IMPROVEMENT PERMIT DENIAL

Re: Application for improvement Permit for property located at 8721 Korniv Dr Charlotte , 03302238

Health Department File 12416B

SOIL/SITE EVALUATION for ON-SITE WASTEWATER SYSTEM

Soil & Site Evaluation Map

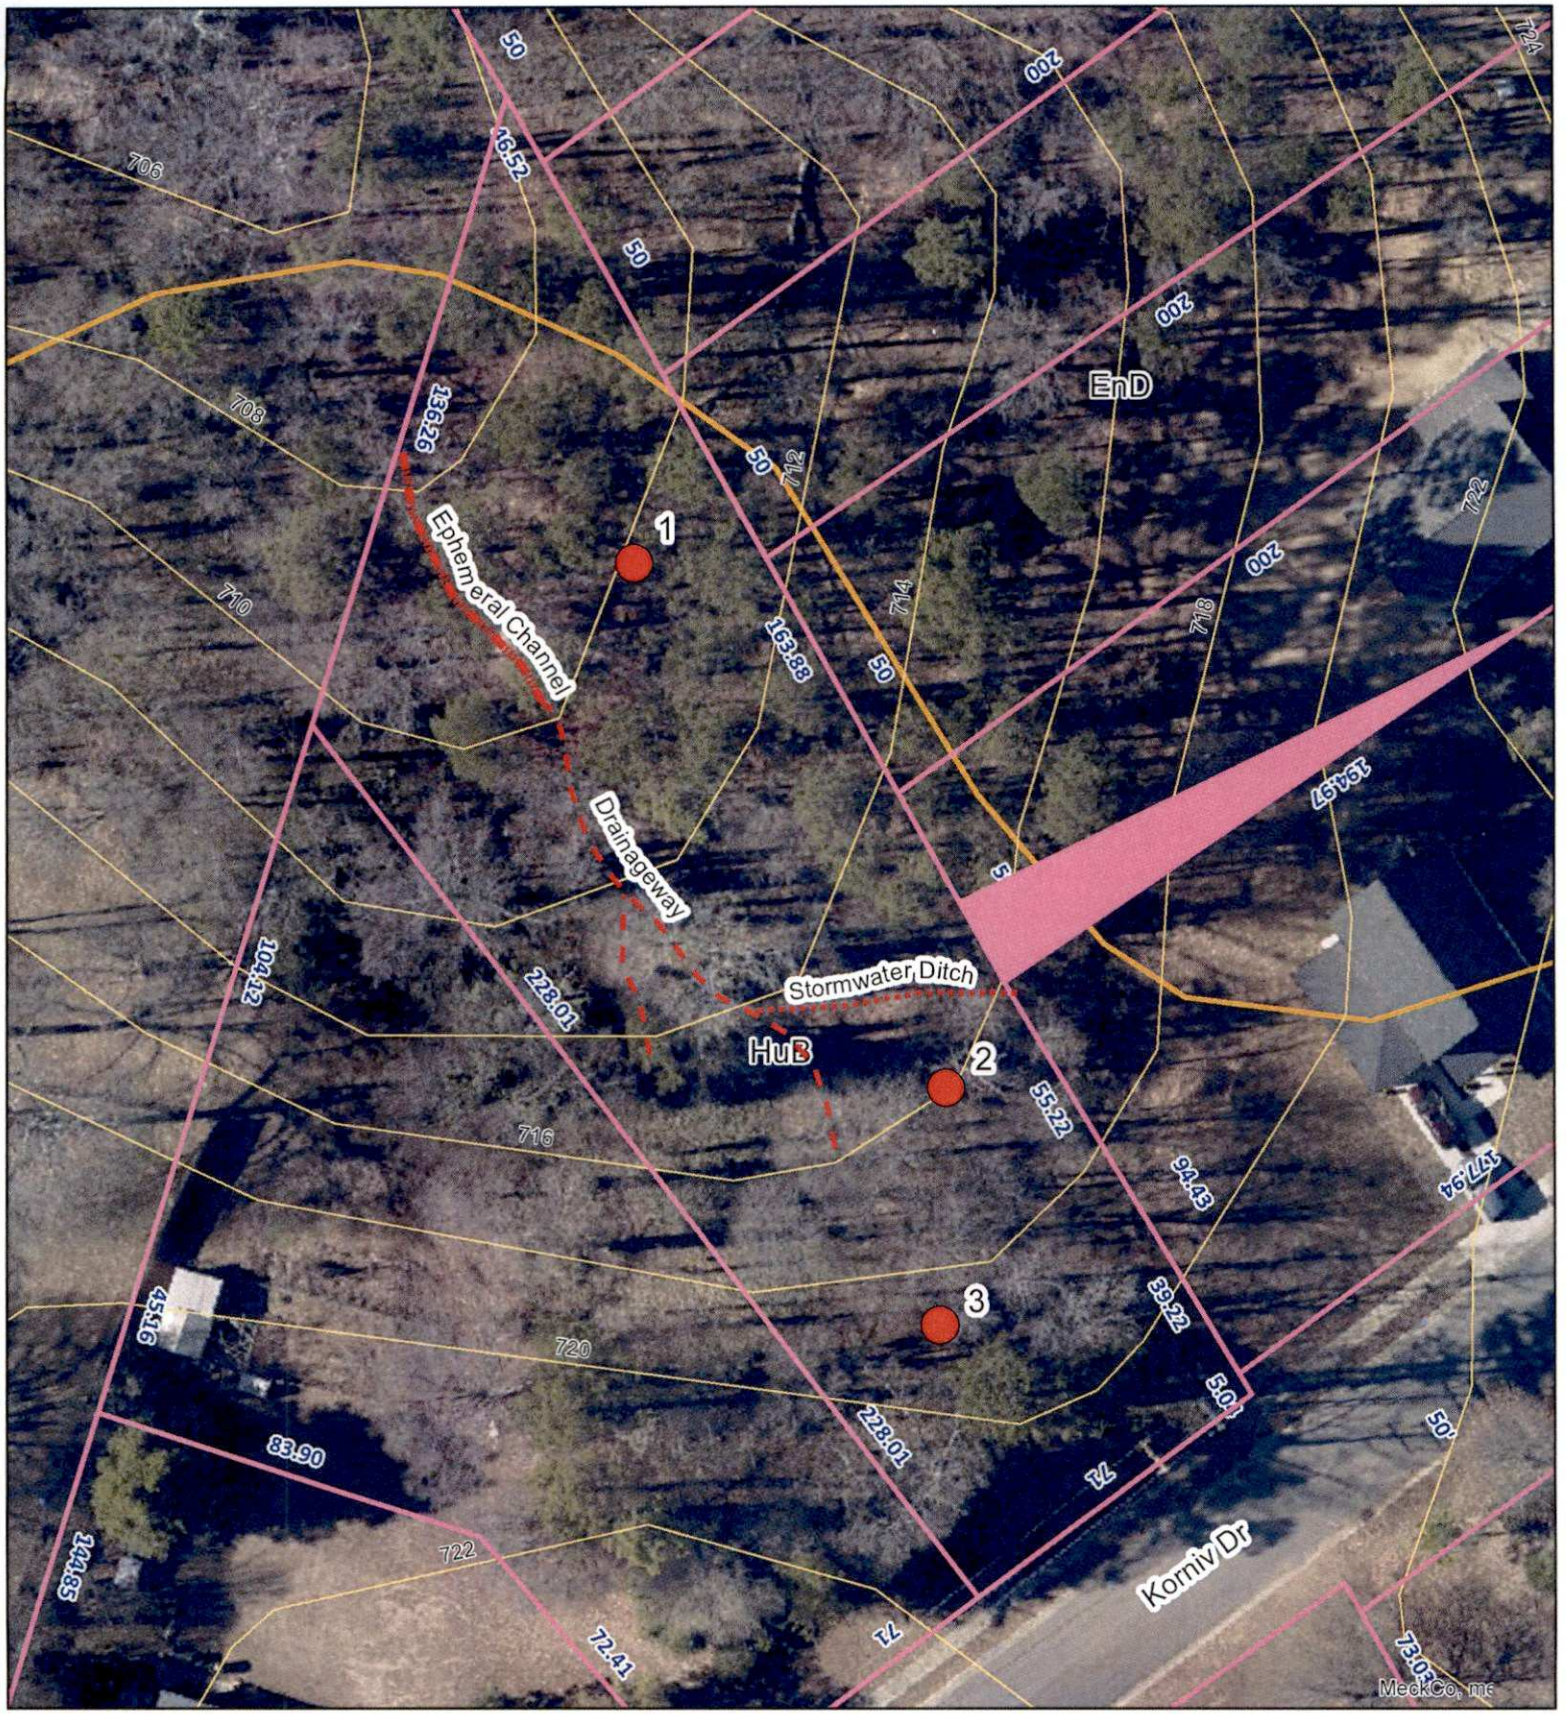
Based on the criteria set out in 15A NCAC 18E .0501 through .0602, the evaluation indicated that the site is **UNSUITABLE** for an on-site wastewater system. Therefore, we must deny your request for an Improvement Permit. A copy of the site evaluation is enclosed. The site is unsuitable based on the following:

- ☐ Unsuitable soil topography and/or landscape position (Rule .0502)
- ☒ Unsuitable soil characteristics (structure or clay mineralogy) (Rule .0503)
- ☒ Unsuitable soil wetness condition (Rule .0504)
- ☐ Unsuitable soil depth (Rule .0505)
- ☐ Unsuitable saprolite (Rule .0506)
- ☐ Presence of restrictive horizon (Rule .0507)
- ☐ Insufficient space for septic system and repair area (Rule .0508)
- ☐ Unsuitable for meeting required setbacks (Rule .0601 or .0602)
- ☐ Other (*Cite applicable rule*):_____

COMMENTS: Site is unsuitable due to unsuitable depth to soil wetness and unsuitable topography.
